Vedr.: M2/X2 software revision 32	PUP nr.:	20-010
	Udarbejdet af:	KSM
	Dato:	11-08-2020
	Intern <input type="checkbox"/>	Ekstern <input type="checkbox"/>

Regarding: M2/X2 software revision 32	PUP No.:	20-010
	Prepared by:	KSM
	Date:	11-08-2020
	Internal <input checked="" type="checkbox"/>	External <input checked="" type="checkbox"/>

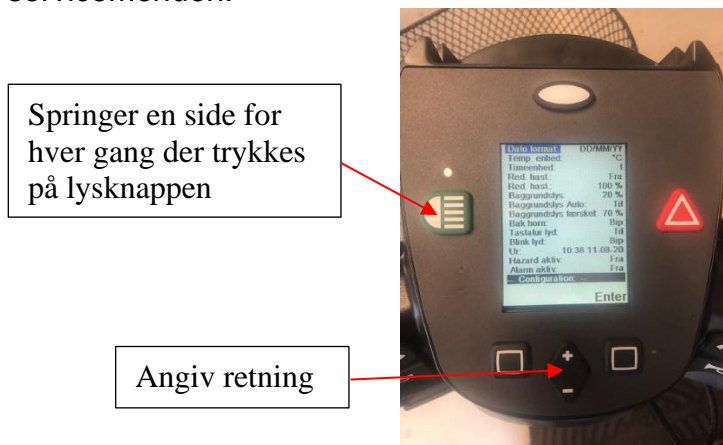
Der er indført mulighed for at springe en side ad gangen i servicemenuen. Hvis der trykkes én gang på minustasten for at angive retningen nedefter og derefter trykker på lysknappen vil man springe én side ad gangen for hver gang man yderligere trykker på lysknappen.

Hvis man trykker på plus knappen og derefter trykker på lysknappen vil man ændre retning og springe en hel side for hver gang der efterfølgende trykkes på lysknappen.

Lysknappen tænder og slukker ikke lyset når denne funktion benyttes i servicemenuen.

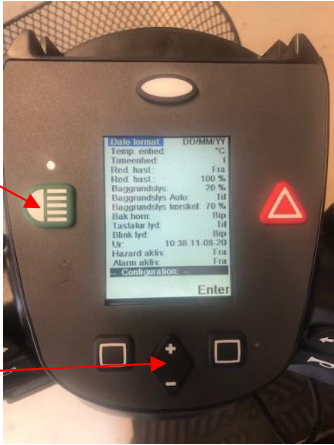
We have introduced the possibility of jumping one full page in the service menu.

If you press one time on the minus button to indicate the direction down and there after presses the light button you will jump one full page every time you press the light button in the down ward direction here after.

If you press one time on the plus button to indicate the direction up and there after presses the light button you will jump one full page every time you press the light button in the upward direction.

The light button will not turn on and off the lights when doing so when you are in the service menu.

Jumps one full page each time you press the light button.

Indicate direction
